NEW BEDFORD WATER WORKS

WATER SERVICE PERMIT

ASR-D.P.I. Engrg.

RE: TB-16-3117

Proposed Site Plan

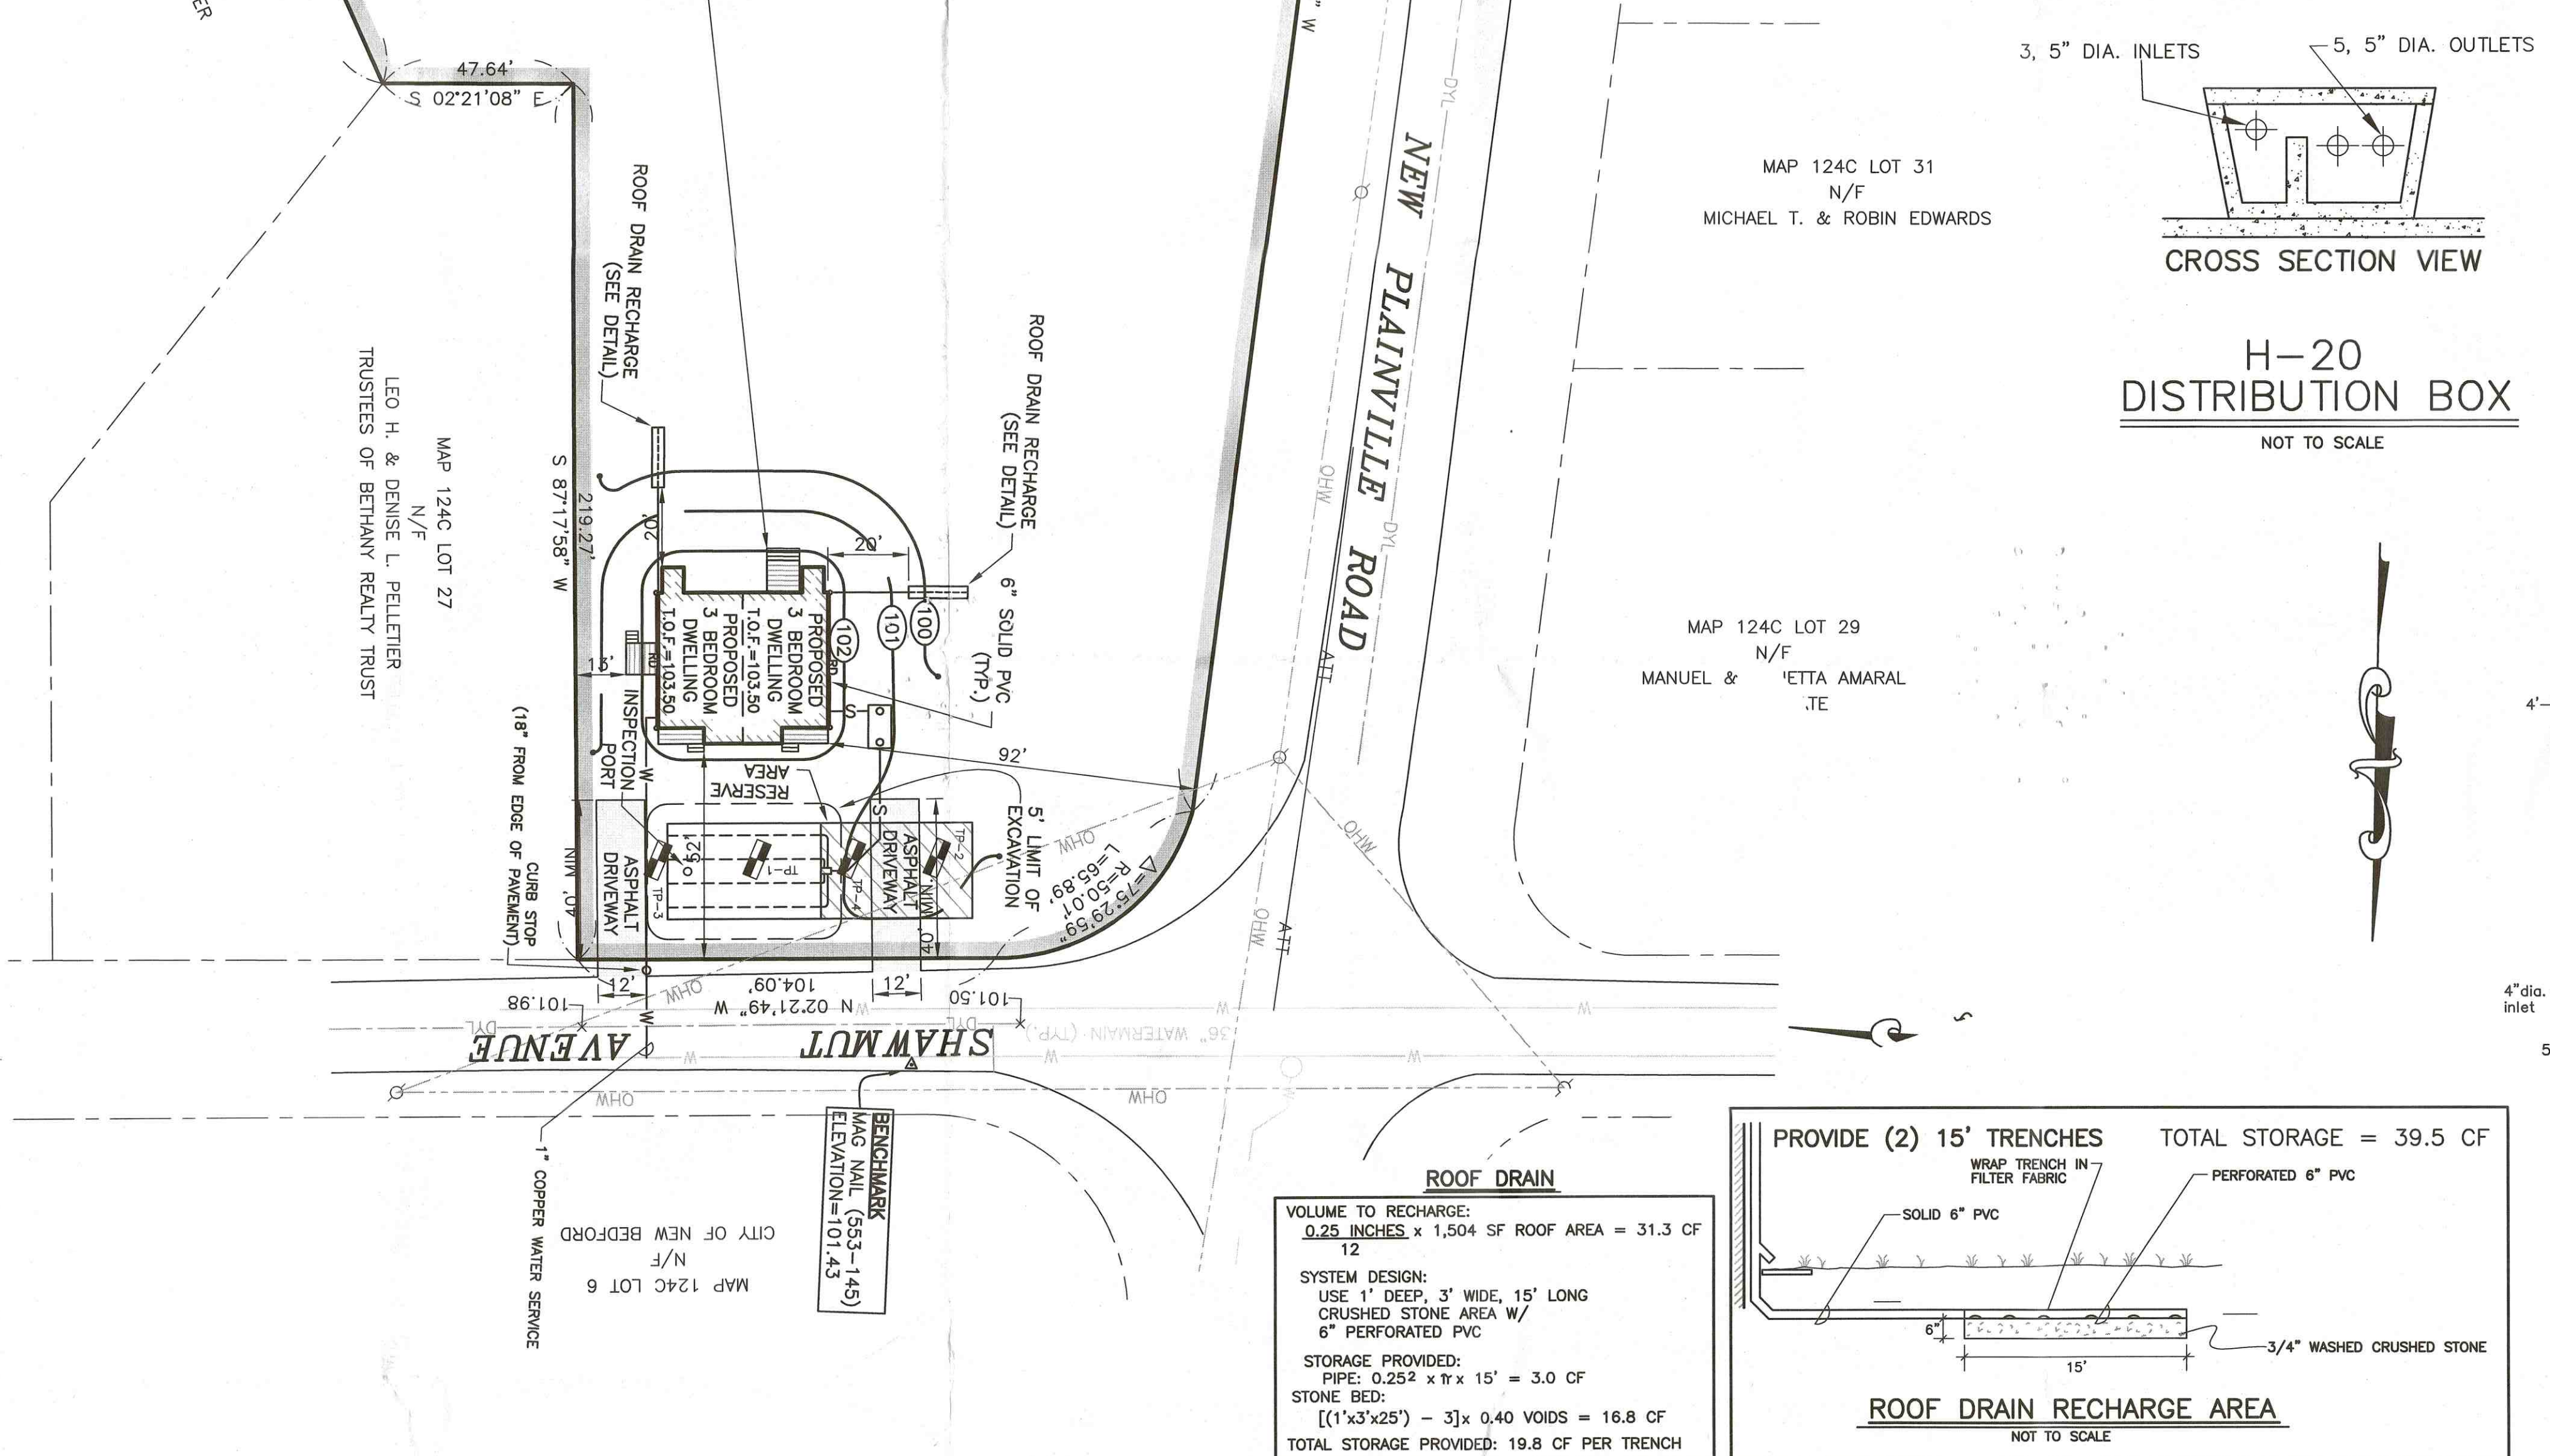
- 1.) The revised site plan submitted to D.P.I., titled "Subsurface Sewage Disposal System, Assessors Map 124C Portion of Lot 27 Shawmut Avenue/New Plainville Road, New Bedford, MA 02745", dated 1/31/2017, with a revision date of 9/22/2017, prepared by Sitec, Inc. and signed/stamped by Steven D. Gioiosa, P.E.-Civil, was approved conditionally, pending the following revisions and submittal of the following before applying for permits at D.P.I.:

- a. Drawing title should reflect what it is intended for (i.e. Building Permit Plan, Proposed Site Plan, etc.). The plan title should have been changed from "Subsurface Sewage Disposal System" to "Building Permit Plan" or "Proposed Site Plan".

- b. Must update Assessor's Parcel ID information to Assessors Map 124C Lot 52 to reflect the proper information for the parcel.
- c. The Owner/Agent needs to provide a permit from the B.O.H. issued for the installation of a new septic system on Lot 52 for the new duplex residence to be built. [On 9/26/17, when Mr. Christopher Ciano dropped off the revised plan, he was asked why they still did not provide the 10' separation from the septic system. Mr. Ciano claimed that Sitec told him there was a 5' overdig on the leaching field, and that they'd be able to meet the 10' separation required. If upon inspection by D.P.I., the separation distance has not been met, he will have to relocate his water service to comply.]

1. Permit is incorrectly filed under Plot 128/Lot 24 in view permit. Please consult with Inspectional Services to assure that it is moved to the correct parcel id.
2. Size/type of proposed water service needs to be specified on plan. Water curb stop must be 1-1/2' from curb (or edge of road pavement), within the sidewalk area. Any bends in the water service must remain within the private property, and a 10' separation distance must be maintained from sewer service/septic system.
3. Type of driveway brows proposed must be called out (i.e. bituminous concrete, cement concrete, etc...).
4. Roof runoff must be infiltrated into ground. Show location, calcs. and specs. for proposed recharge system on plan.
